June 30, 2008

**SUBJECT: URBAN DESIGN ADVISORY GROUP COMMENTS TO THE DRAFT  
ENVIRONMENTAL IMPACT STATEMENT**

DRAFT -Design Guidance for the Columbia River Crossing Project

#### Exhibit 3-6. North Bank & SR 14 Interchange

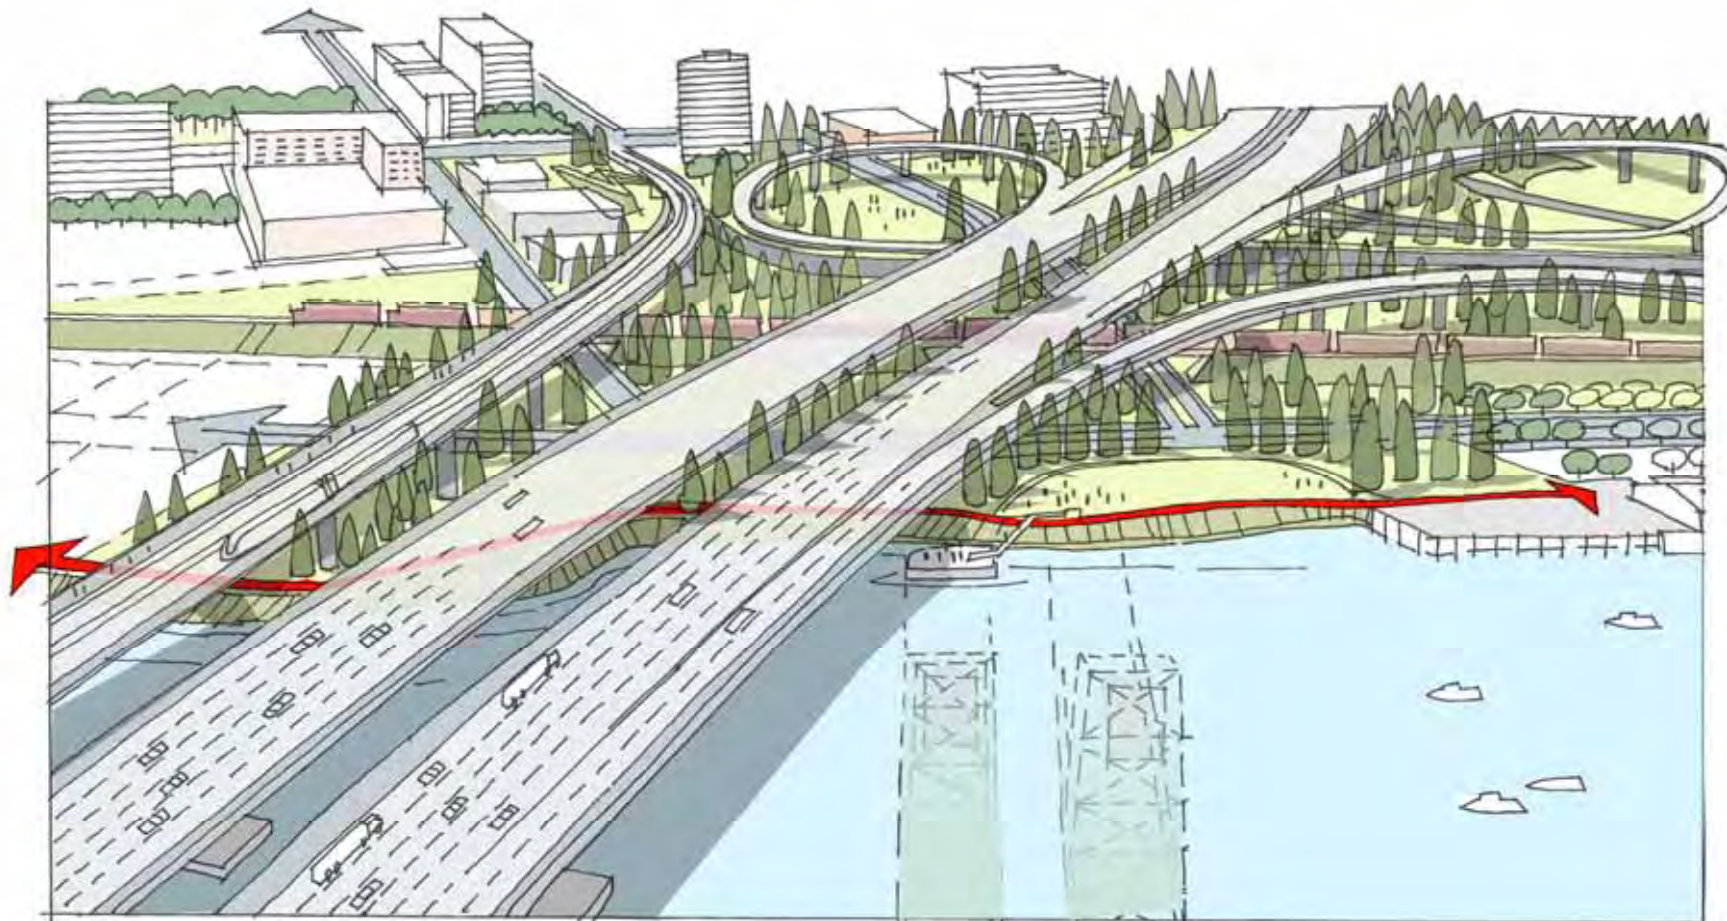
25. Designate a continuation of the regional trail through this space. *Include continuation of the waterfront trail.*

30. Connect the Land Bridge and Apple Tree Park with downtown Vancouver by combining improved sight lines, improved access and integrating landscape design. *Provide visual and physical connections between under-bridge structures.*

31. Extend landscape treatment associated with the Land Bridge all the way to the river via the BNSF underpass. Also provide a landscaped trail to Main Street extended south to Columbia Way. *Extend Land Bridge landscaping under the bridges.*

32. Design open space within the SR 14 interchange to treat but not detain storm water runoff, reduce broadcast of traffic noise, integrate structures into the landscape, accommodate active open space and provide integral security for structures. *Introduce active and functional uses under the SR 14 interchange.*

Exhibit 3-8. Seventh Street Footbridge

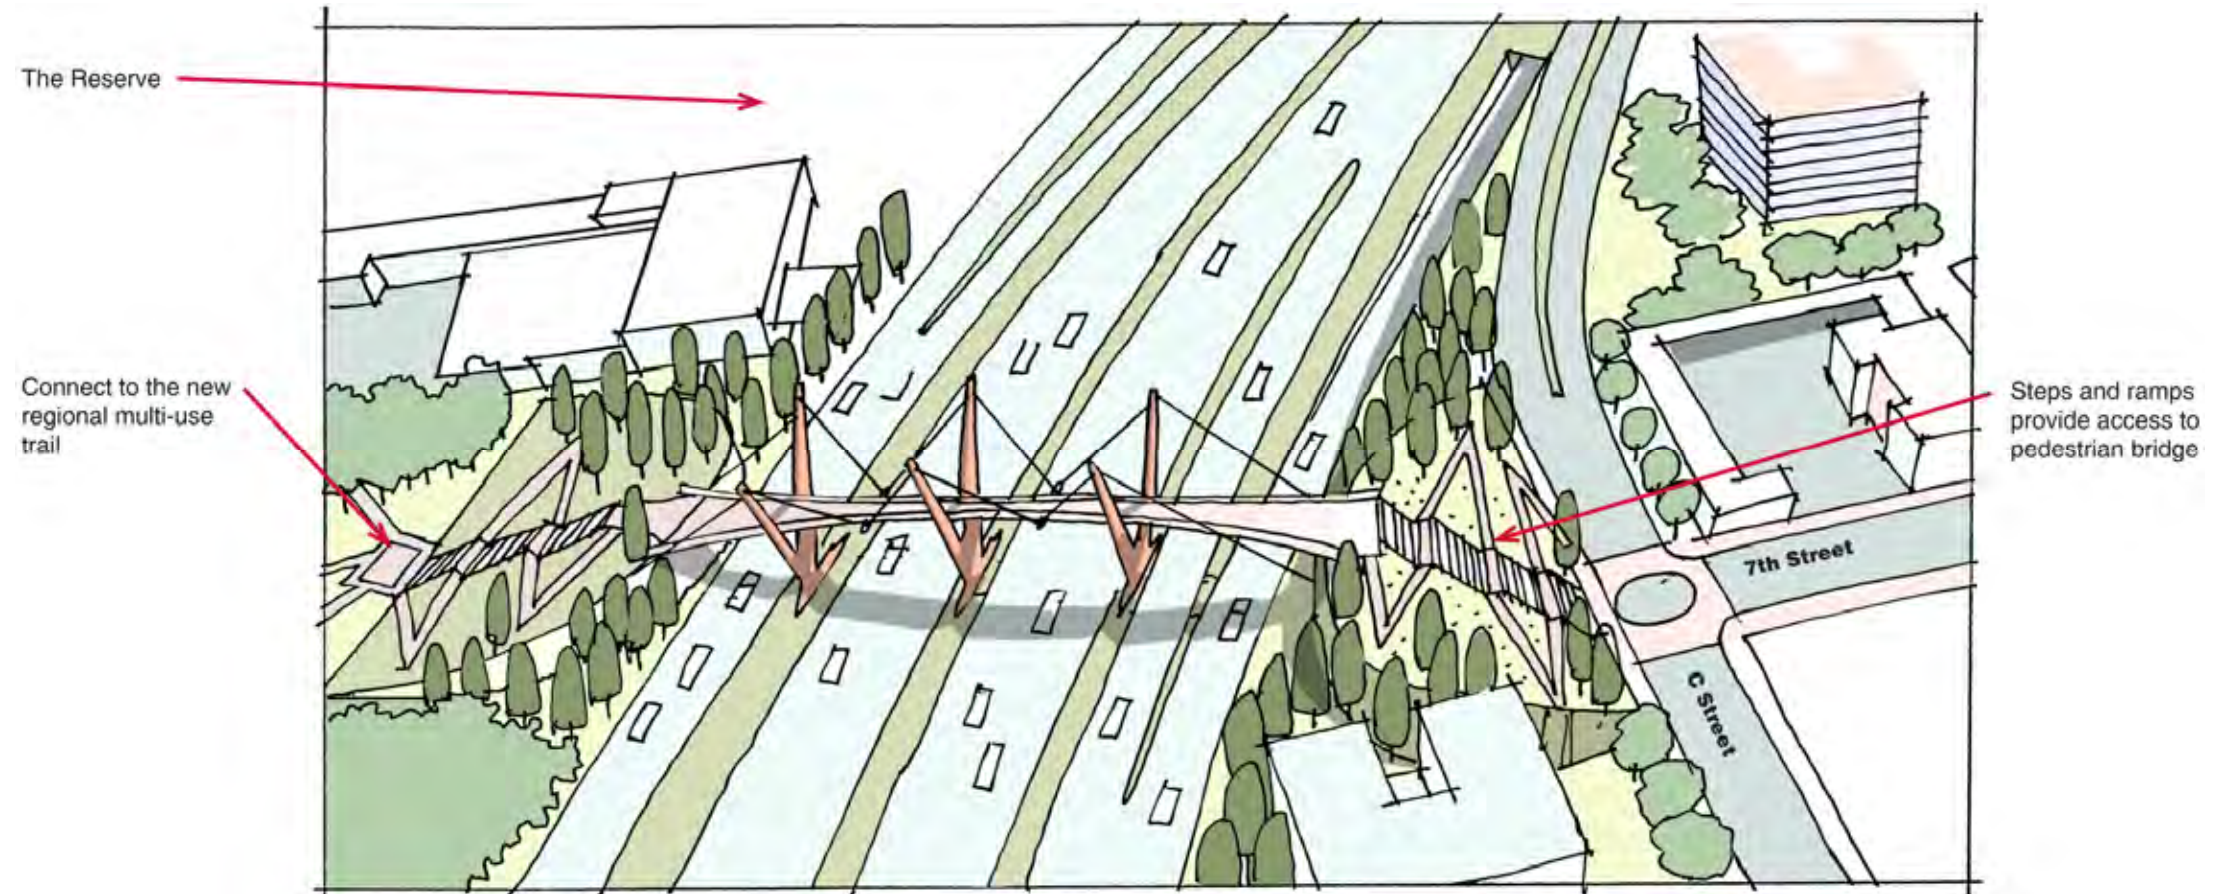
34. Consider the design of the 7th Street footbridge as an opportunity to announce approach to the bridge with an elegant and colorful structure. *Make the footbridge a colorful gateway.*

35. All of the Downtown highway crossings should be addressed functionally and visually as an integrated system. *Consider the collective appearance and function of Downtown crossings.*

**Exhibit 3-10. Mill Plain Interchange****3.2.9 Mill Plain Interchange**

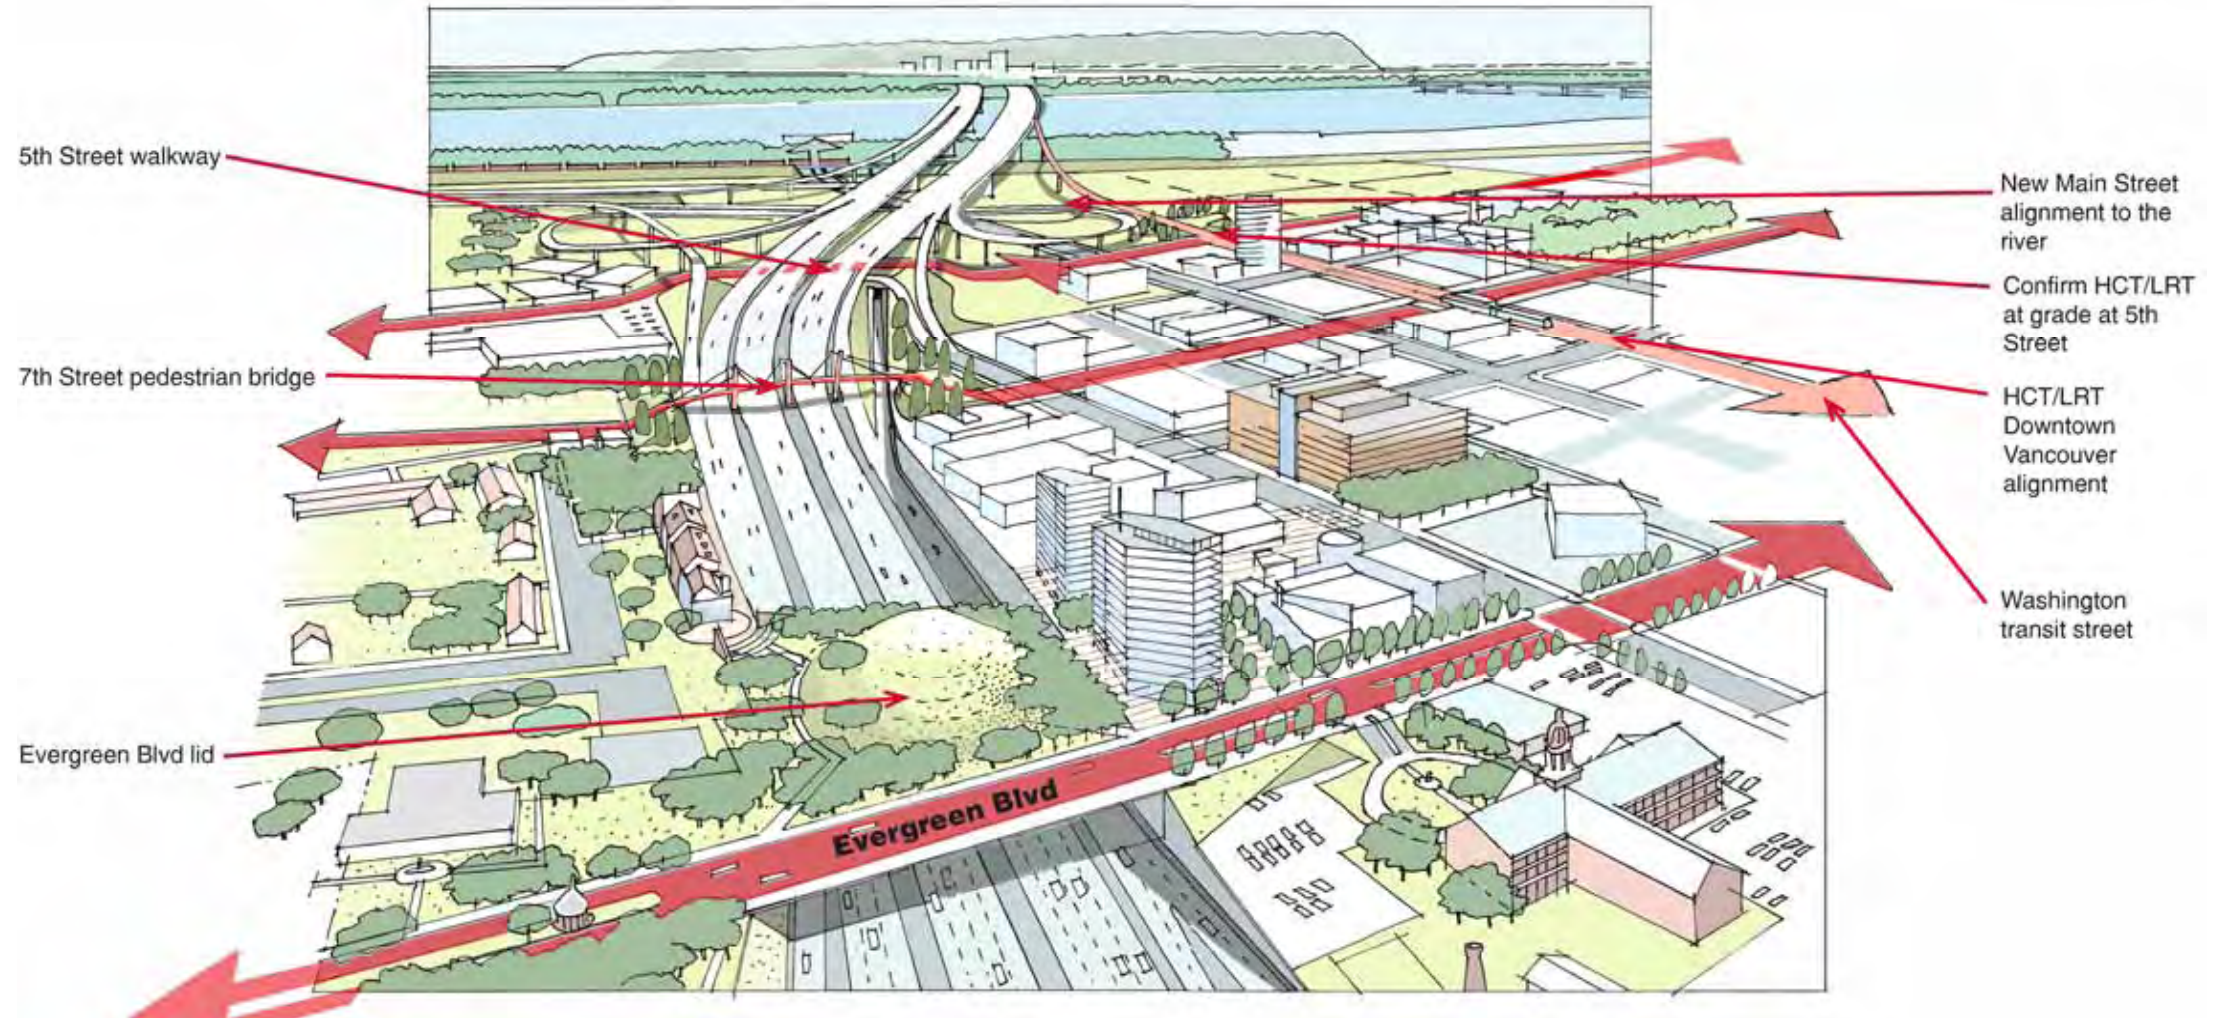
38. Acknowledge through urban design and landscape that Mill Plain is the principal point of access to Downtown from the north and east. *Distinguish the Mill Plain interchange as the principal entrance to Downtown.*

39. Provide safe and direct passage for pedestrians and cyclists on Mill Plain Blvd traveling between destinations east and west of I-5. (The current design appears to address only vehicular traffic needs. Prepare another design that accommodates all modes equitably). *Improve pedestrian and bicycle safety under I-5.*
